Report Number: 11827

Horndon Significant Meter Error Report

Summary of Comments on Microsoft Word - Horndon SMER NT008
GL Report 11827.doc

Site name	Horndon Offtake
DNO	National Grid Gas Distribution
LDZ	North London
Error start date	15 th September 2008
Error corrected date	7 th July 2010
Size of error (over or under read)	160.53 GWh under-registration
Error description	Following a temperature transmitter replacement the connections between the element and the transmitter became loose. This resulted in an increase in resistance and hence an over-read of temperature.
Meter type	Orifice Plate
SMER Unique Reference No	NT008
Compiled by	Ben Kirkman (GL Noble Denton)

Figure 2.2 - Unexpected temperature step change at Horndon

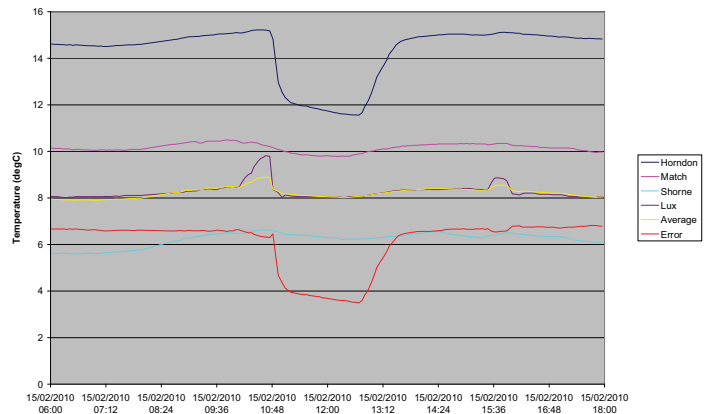
- Author: jkrawac Subject: Sticky Note Date: 25/11/2011 09:41:21
This need to be explain how a change in gas composition result in a temperature change.
The changes shown later are not significant so need to define what is meant by this term. In my experience small changes in gas composition do not affect the temperature as the change in thermodynamic properties of the gas a s a result in insignificant.

Figure 2.5 - Daily mean temperature differences

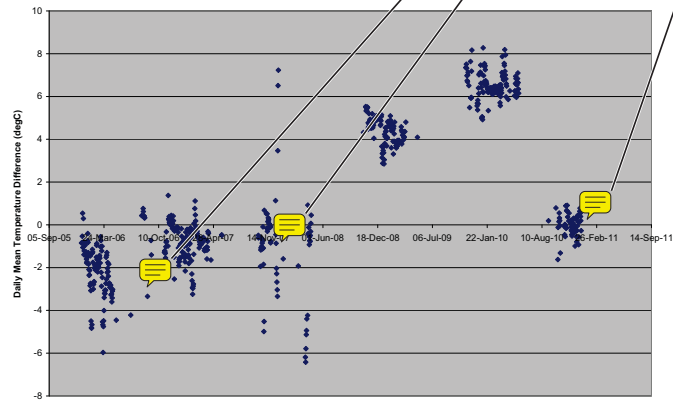
- Author: jkrawac Subject: Sticky Note Date: 25/11/2011 09:51:52
These distributions are poor, e.g. a bias of +1.15 at Shorne with a deviation of +/- 0.99.
- Author: jkrawac Subject: Sticky Note Date: 25/11/2011 09:52:55
This is the distribution you would expect, centred around zero.
- Author: jkrawac Subject: Sticky Note Date: 25/11/2011 09:53:21
This has a very wide distribution so something must be amiss
- Author: jkrawac Subject: Sticky Note Date: 25/11/2011 09:53:45
These two should also be corrected for as they are biased.

Figure 3.1 - January to April 2006 temperature profile

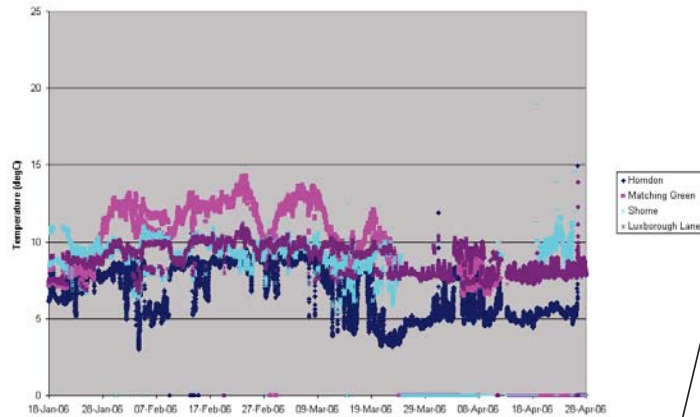
Author: jkrawac Subject: Sticky Note Date: 25/11/2011 09:56:15
Disagree as the graph shows definite negative errors

Figure 3.2 - Correlation of pressure differential and temperature

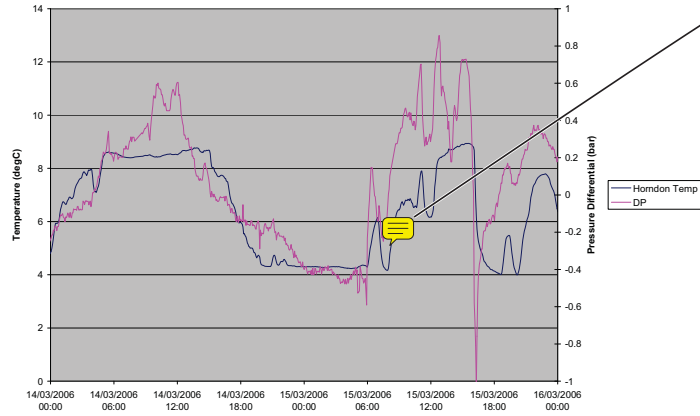
Author: jkrawac Subject: Sticky Note Date: 25/11/2011 09:58:15
This source gas temperature is likely to be the true cause of the temperature differences and not the gas compositions.

Figure 3.7 - Temperature and error profile for 15th September 2008

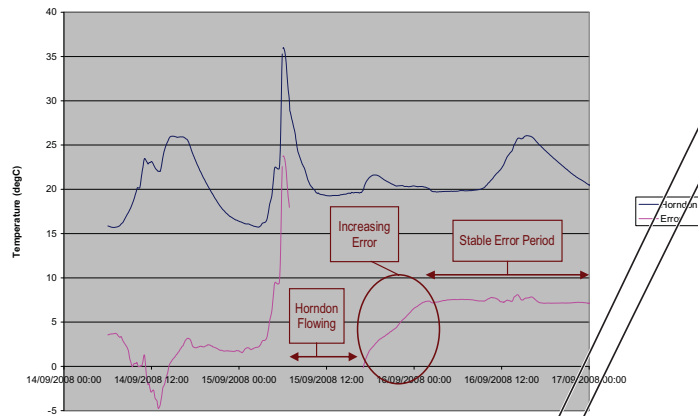
- Author: jkrawac Subject: Sticky Note Date: 25/11/2011 10:07:10
Why is only the first 24 hours used for all of this error?
Surely there are other stable periods but these are not shown

- Author: jkrawac Subject: Sticky Note Date: 25/11/2011 10:06:57
This is not shown and should be
